INNER WEST COUNCIL

DEVELOPMENT ASSESSMENT REPORT

Application No.	DAREV/2018/21
Address	184 Nelson Street, ANNANDALE NSW 2038
Proposal	Review of Determination of Condition 2(a) which requires that the steel beam shown at first floor level to be deleted or set behind external wall cladding, plus correct determination to reflect consent issued under M/2017/53 which deleted Conditions 3, 6, 19, 20, 42 and 43.
Date of Lodgement	24 December 2018
Applicant	Mr J H Davis
Owner	Mr J H Davis
Number of Submissions	Nil submissions
Value of works	\$75,000.00 (Original cost of works)
Reason for determination at Planning Panel	Initial Development Application was determined by the Planning Panel
Main Issues	No Issues
Recommendation	Approval
Attachment A	Recommended conditions of consent
Attachment B	Plans of proposed development
Attachment C	Statement of Significance for Conservation Area

SECTION B-B

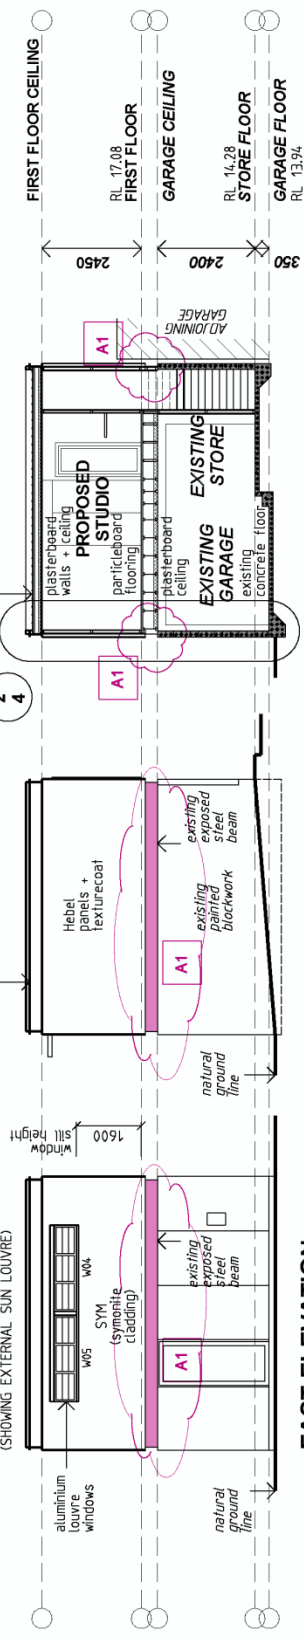
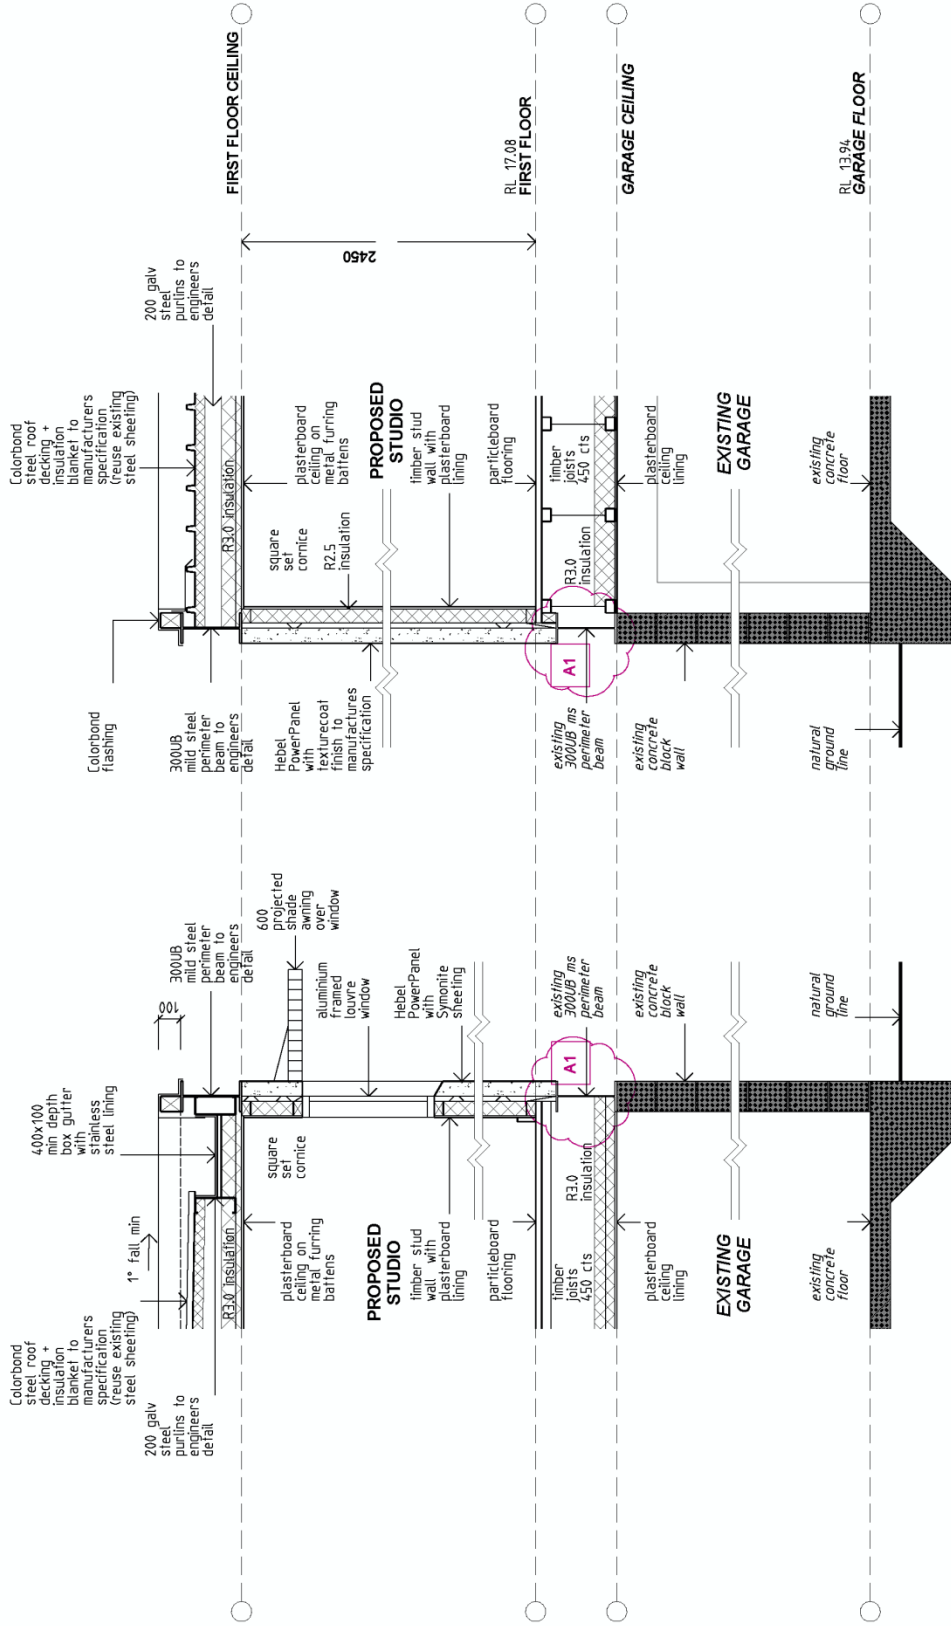
The modification to retain the unclad existing beam at first floor level is not supported as this detail will be out of character with other development along Trafalgar Lane. The proposal needs to be amended to ensure it complies with Condition 2. a).

The use of exposed steel beam is inconsistent with the overall historic character of the laneway. However, this is considered a minor change to an already modified laneway and it is not considered to have adverse impact over the heritage conservation area.

- A1. Maintain existing beam at first floor level uncladded.
- A3. Change louvre windows to clear glass and full opening.
- A4. Desic external sun louvers to 35 degree max. opening.
- A5. Add door between garage and studio stairs. (02)
- A6. Add door between garage and studio stairs. (02)

The proposal does not require amendment to comply with Condition 2. a).

Comment: A site inspection with Council's Assessment and Heritage Officers was undertaken on the 11 February 2019 and has found that the overall historic character of Trafalgar Lane has been significantly altered. As a result, it was agreed between the assessment and heritage officer that the proposal to leave the steel beam exposed will have minimal adverse streetscape and heritage impacts given the already altered mixed character of development on Trafalgar Lane. Also, for the reasons outlined in the heritage referral comments, the proposal to delete condition 2(a) is supported on heritage grounds. This change does not alter approved landscaped area, site coverage or FSR and will raise no adverse amenity impacts on neighbouring properties.
